**ISSUE:** Permit to Demolish/Capsulate (partial) and Certificate of Appropriateness for alterations

**APPLICANT:** 910 King Street, LLC

**LOCATION:** Old and Historic Alexandria District  
910 King Street

Figure 1: Previous (left) and current (right) proposed north elevation

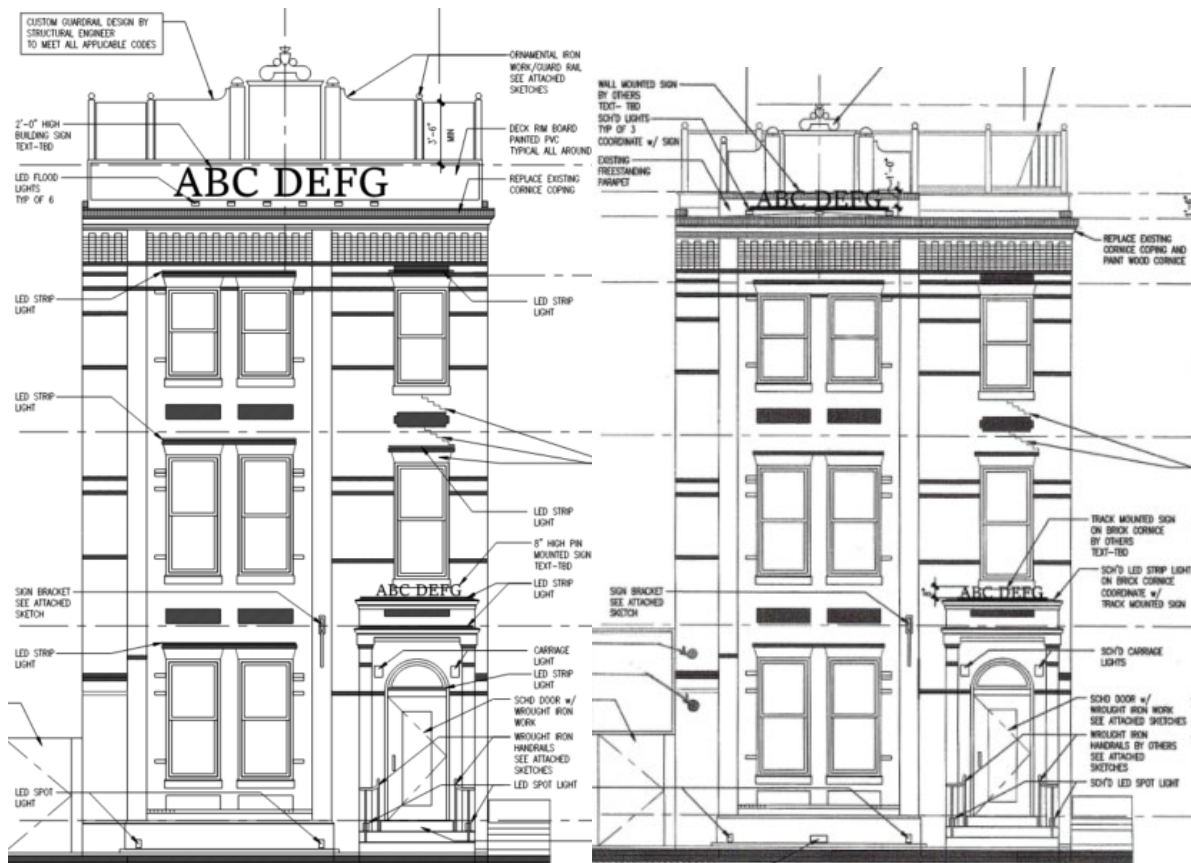
At the last BAR hearing, Board members expressed concern regarding the height and design of the proposed roof deck and associated roof structure and railings. At that time the top of the roof deck was 6'-2" above the bottom of the third floor ceiling framing and the top of the stair enclosure was 9'-0" above the top of the roof deck. The railing surrounding the roof deck was directly behind the parapet on all sides of the roof and included a highly decorative focal point centered on the front elevation.

Since the last hearing, the applicant has revised the proposal in response to comments from the Board (Figure 1 & 2). This revision serves to lower the roof deck and pull the railing back from the front edge of the roof. In the current proposal, the top of the roof deck is 5'-3" above the bottom of the third floor ceiling framing and the railing has been relocated behind the existing rooftop knee wall. The height and design of the stair enclosure remains unchanged. Instead of locating the decorative focal point on the railing, it is now being proposed on top of the existing knee wall.

As noted above, the Board's comments regarding the proposed roof deck were largely related to the visibility of the roof structures and the perimeter railing. The *Design Guidelines* state that "Roof decks should be constructed so that they do not interfere with the historic roof-line of a building." There are numerous roof decks located on historic buildings throughout the district, including elsewhere on this block. Where the BAR has previously approved roof decks, they have indicated that the deck construction should be as close to the existing roof as possible so as not to disrupt the existing roof line.

In response to BAR comments, the applicant has reduced the height of the roof deck, lowering it closer to the existing roof surface and has pulled the edge of the roof deck away from the north edge of the roof and behind the existing knee wall (Figure 5). Staff finds these to be improvements to the design; however, the comments regarding the visibility of the stair enclosure when viewed from the west have not entirely been resolved. In order to address the comments related to the stair enclosure, staff recommends that the applicant work with staff to explore ways in which the massing can be diminished or moved to the southeast corner of the building where visibility from the street will be obscured by other buildings.

1. The applicant will work with staff to explore ways in which the massing of the stair enclosure can be diminished or its visibility limited by relocating it to another part of the roof.

**Figure 2: Previous (left) and current (right) proposed west elevation**

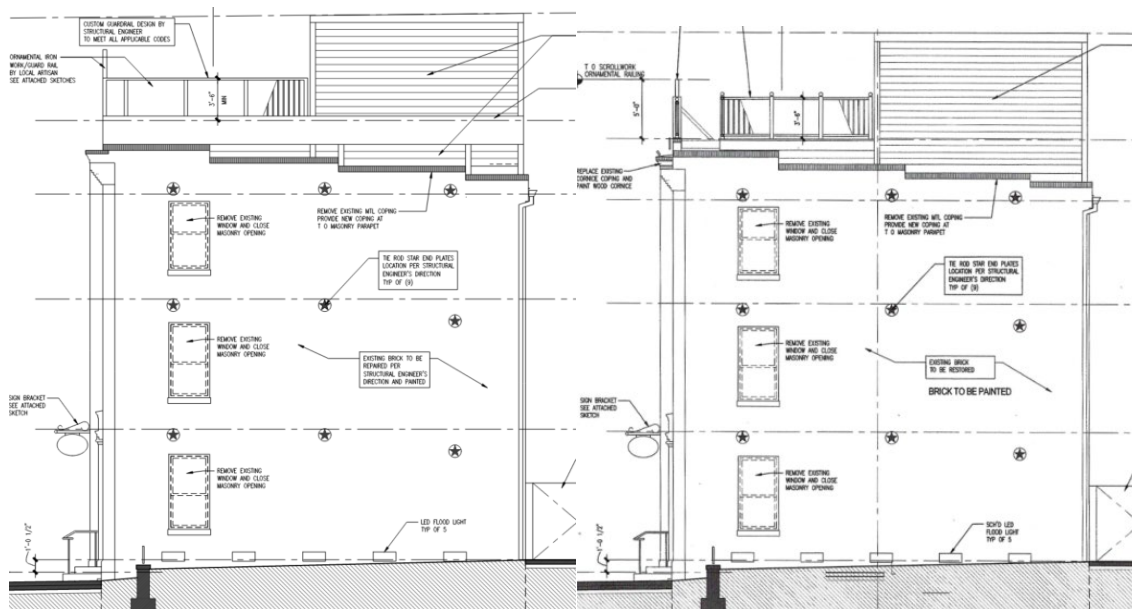
Staff appreciates the revised proposal which eliminates the painting from the King Street façade; instead the brick in this area will be repaired and restored. There was much discussion regarding the painting of the east, south and west elevations during the previous hearing with Board members expressing concern about the change in building character that this painting would cause. As noted above, until the mid-twentieth century an adjoining building was attached to the west side of the current building. At the south side of the building was originally located an ell which predated the construction of the portion of the building remaining today. As these two elevations were not intended to be exterior walls, the masonry in these areas is not consistent and of a finished quality. With that, staff recommends that the applicant paint the west and south exterior walls and that the north and east walls remain unpainted.

6. The painting of the south and west elevations be allowed and the painting of the north and east elevations be denied.
7. The applicant will work with staff on the installation, color temperature, and intensity of the proposed lights.

Figure 4: 1941 Sanborn Map showing structure at front of lot at 912 King Street

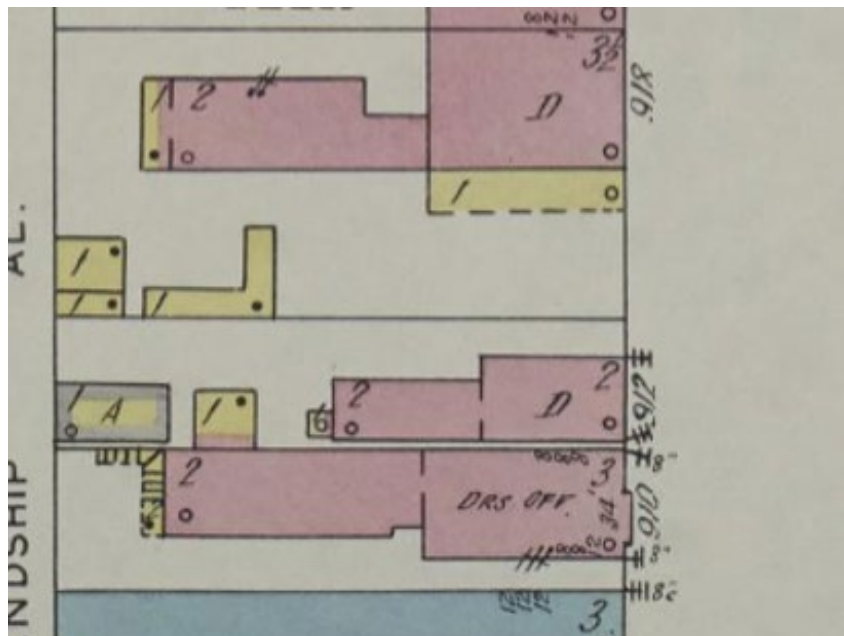
The analysis of the standards indicated above relate only to the portions of the wall areas proposed for demolition/capsulation. In the opinion of staff, none of the criteria for demolition and capsulation are met and the Permit to Demolish/Capsulate should be granted. The area of the roof to be demolished dates from 1892 and is not of unique construction or materials. The windows on the west elevation that are to be enclosed are not original to the building, having been added upon the demolition of the structure previously located at 912 King Street, sometime after 1941 (Figure 4). As such, staff recommends approval of the Permit to Demolish/Capsulate (partial).

Figure 6: Design for decorative metalwork on top of the masonry knee wall

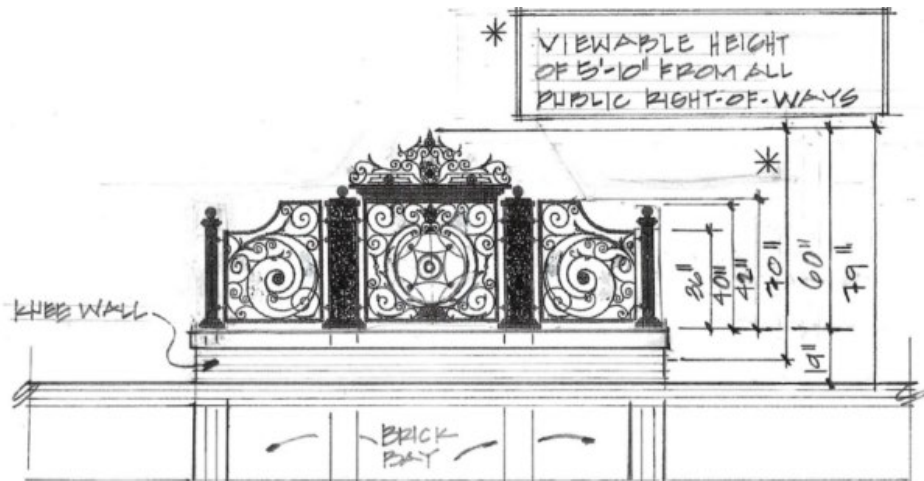
Another roof mounted structure on which the Board commented is the three part decorative metal work that previously was integrated into the roof deck railing. Board members noted that the design and size were too large for the building and detracted from its historic character. In the revised design, the railing has been moved back from the northern edge of the roof and this decorative element has been moved to sit atop the knee wall at the top of the projecting bay (Figure 6).

Staff finds that the revised design does not address concerns from the Board regarding the compatibility of the metal work with the historic building. Staff appreciates that elements of the design have been taken from the decorative brickwork on the front of the building, however the size and complexity of this element overpower the historic building. As noted in the submission material, the building across King Street from the subject property has many of the same historic details and in many ways can be considered a sibling to this building. At the top of the projecting bay on this building is a decorative slate roof with a simple metal embellishment (Figure 7). This is in place of the masonry knee wall at the top of the bay on 910 King Street. Staff finds that the metalwork proposed for the top of the knee wall is incompatible with the design of the historic building and recommends that the applicant work with staff to design a metal embellishment of approximately the same scale and complexity as the one on 913 King Street.

2. The proposed metalwork at the top of the knee wall is incompatible with the design of the building; if an embellishment is installed in this location the applicant will work with staff to design an element of approximately the same scale and complexity as the one on 913 King Street.
